**Addendum No. 1  
BL114-23  
Turkey Crossing Pump Station and Force Main**

*The following addition/changes modify the Bid No. BL114-23 "Turkey Crossing Pump Station and Force Main" Contract Documents, dated November 2023, as first advertised on November 22, 2023.*

## TURKEY CROSSING PUMP STATION AND FORCE MAIN

### PROPOSED SITE PLAN

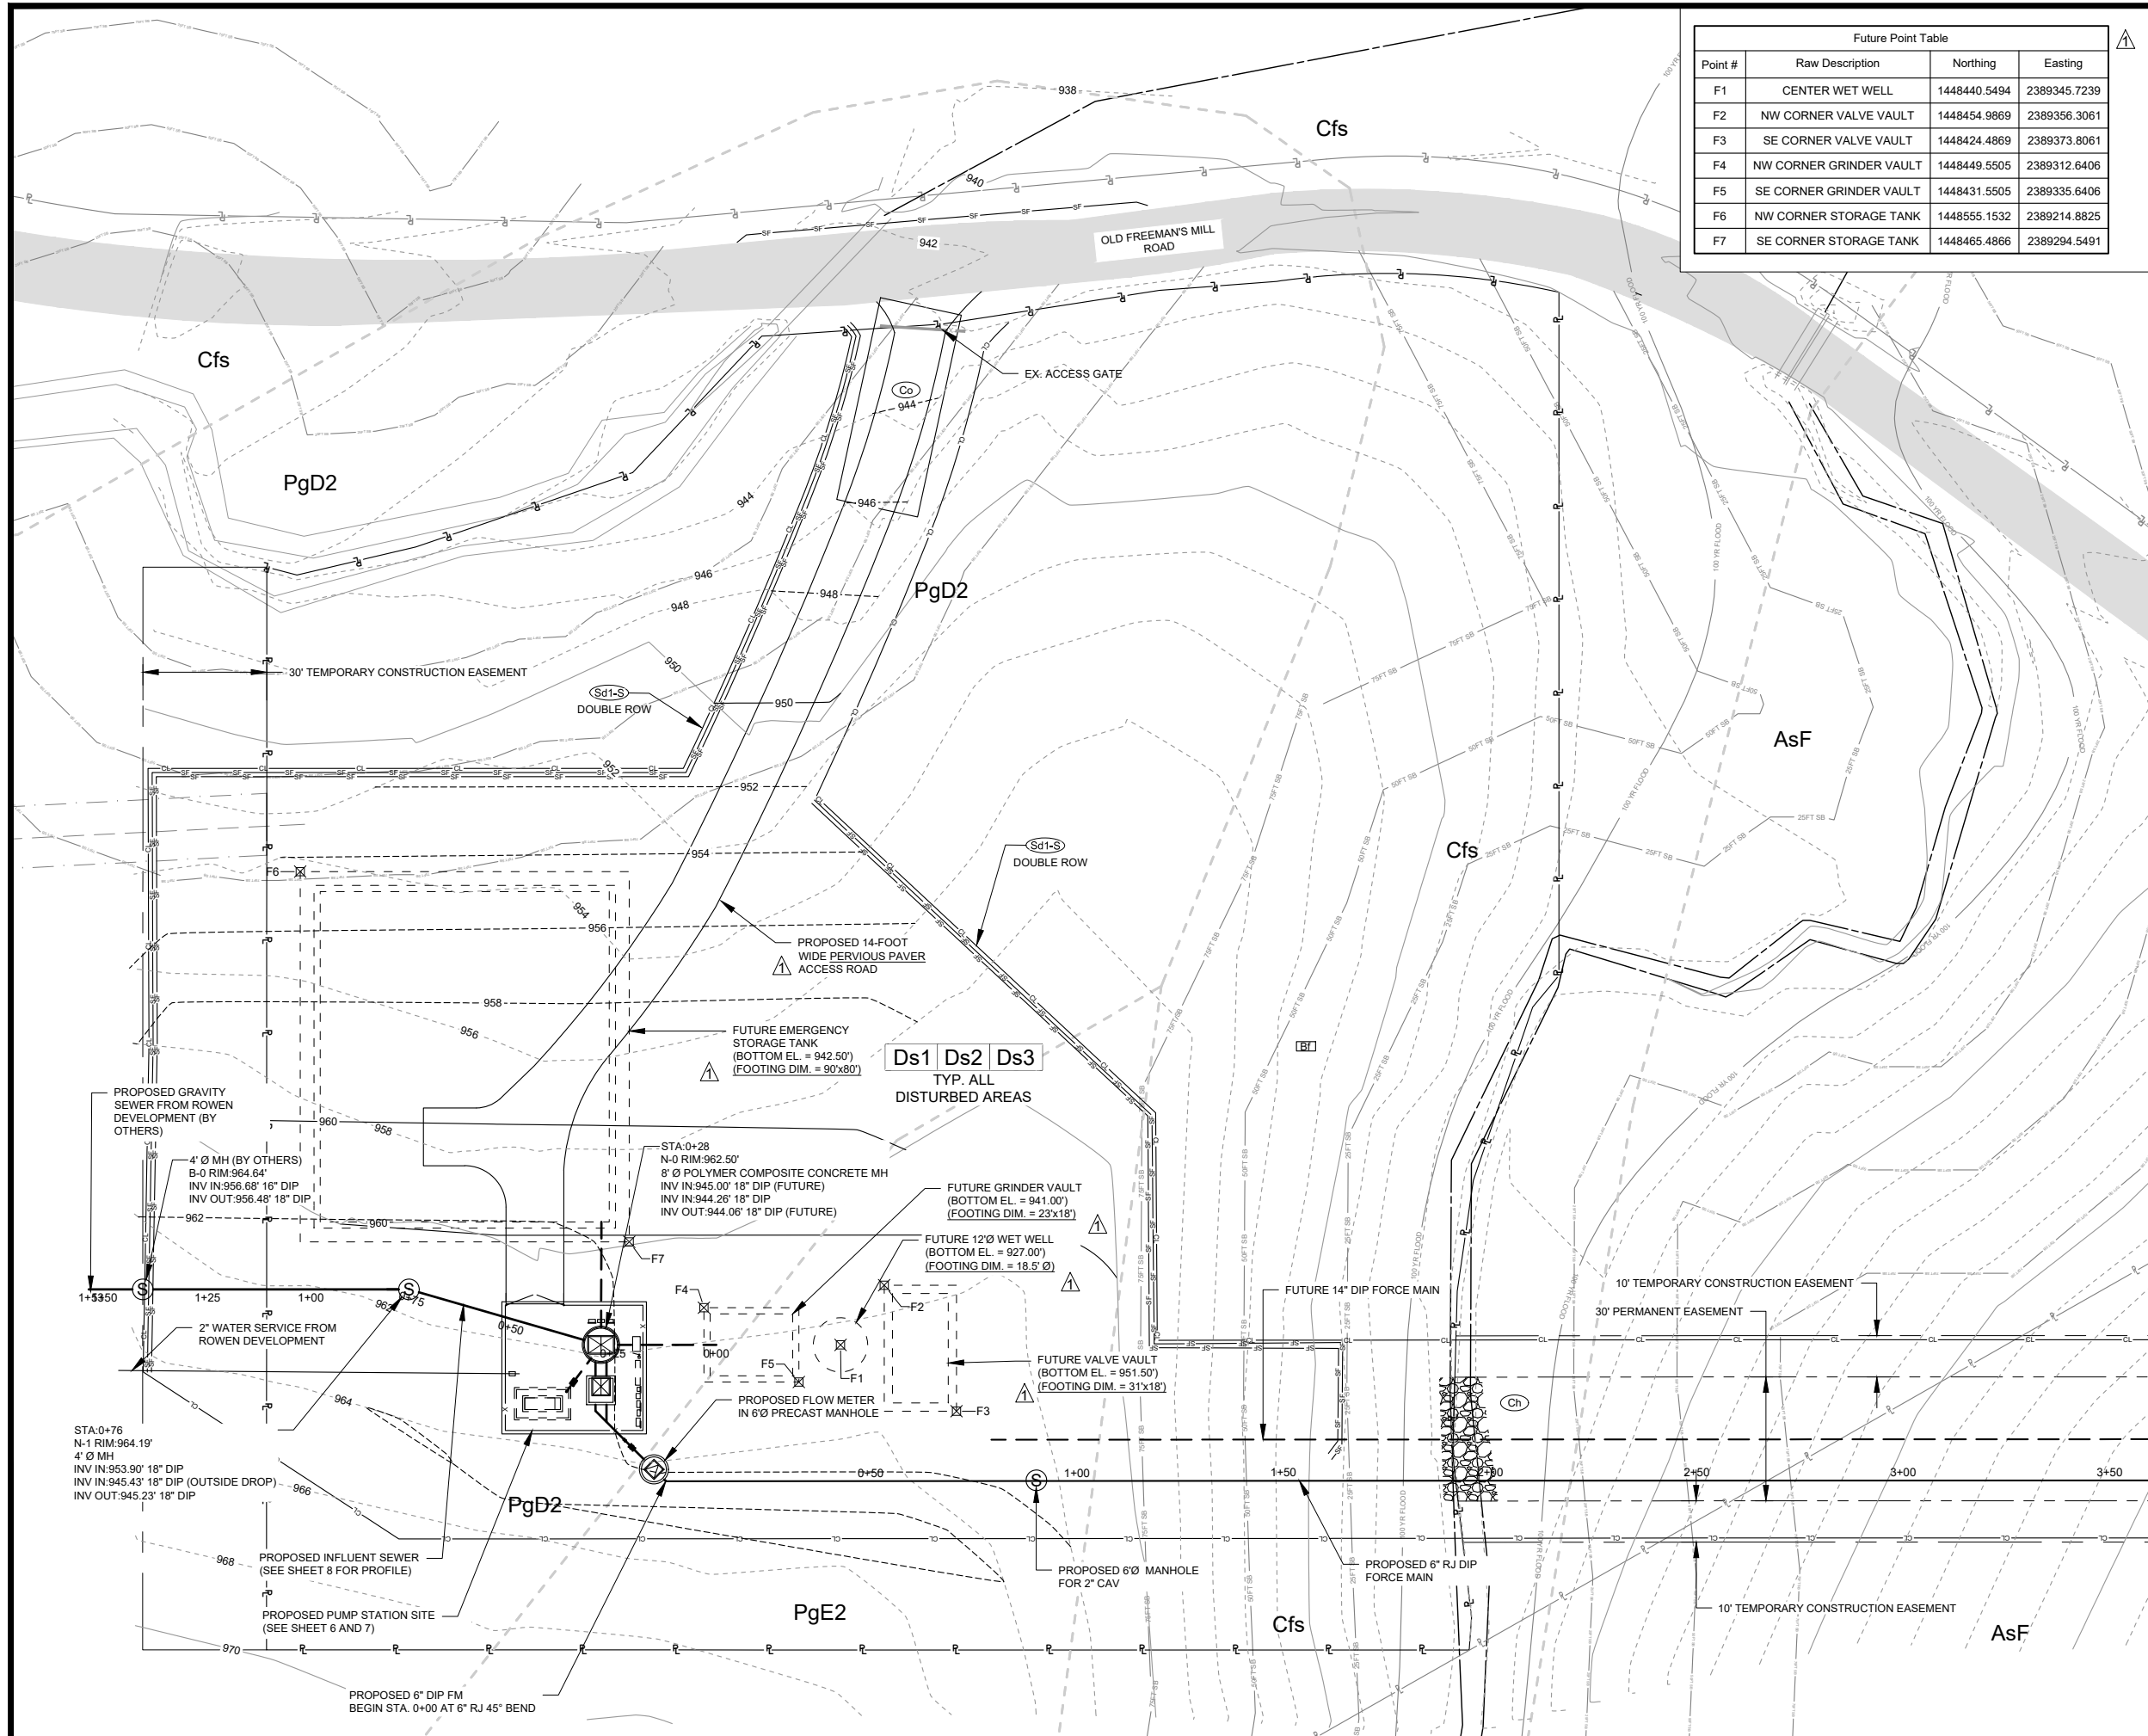
- C2. **REPLACE** Drawing Sheet 5 with the attached revised Drawing Sheet 5.
- C3. On Drawing Sheet 6, **REVISE** the call out "Proposed 14' double leaf security gate" to "Future 14' double leaf security gate".

- A4. See C1.1, above.**
- Q5. Drawing Sheet 5, Note 4 requires rock removal of future structures to a depth 18" below elevation identified. What is the required horizontal distance outside the footprint of the future structure the rock must be removed? Please clarify.

- A6. See C6, above.**
- Q7. Bid Item 1.1 includes erosion control for the pump station site in the lump sum item. Erosion control items for the force main appears to be paid at the unit price bid items under 3.5. What is the dividing line or station number where this transition takes place. Please clarify.

- PRIOR TO INSTALLING THE PROPOSED GRAVITY SEWER, MANHOLES, AND PUMP STATION, THE CONTRACTOR SHALL REMOVE ALL ROCK WITHIN THE FOOT PRINTS OF THE FUTURE STRUCTURES TO A DEPTH OF A MINIMUM OF 18 INCHES BELOW THE IDENTIFIED BOTTOM OF STRUCTURE AND A MINIMUM OF SIX FEET OUTSIDE THE EXTENTS OF THE FOOTING ON ALL SIDES. THE ROCK SHALL BE BROKEN, EXCAVATED, AND HAULED OFF SITE FOR DISPOSAL IN A LEGAL MANNER. THE EXCAVATED AREA SHALL BE BACKFILLED WITH SUITABLE MATERIAL APPROVED BY GCDWR AND THE ENGINEER. BACKFILL SHALL BE PLACED IN 8- TO 12-INCH LIFTS AND COMPACTED TO A MINIMUM OF 95% STANDARD PROCTOR.

- PARKING LOTS SHALL BE MAINTAINED IN GOOD CONDITION, FREE OF POT HOLES, WEEDS, DUST, TRASH, AND DEBRIS.
  - ALL EROSION CONTROL MEASURES WITHIN THE PROPERTY LINES OF THE PROPOSED PUMP STATION SITE AND TEMPORARY CONSTRUCTION EASEMENT TO THE WEST OF THE SITE SHALL BE INCLUDED IN THE LUMP SUM COST FOR THE PUMP STATION WORK. ALL OTHER EROSION CONTROL ITEMS, INCLUDING THE CHANNEL STABILIZATION AT THE STREAM CROSSING SHALL BE INCLUDED IN THE UNIT PRICE WORK FOR THE FORCE MAIN.
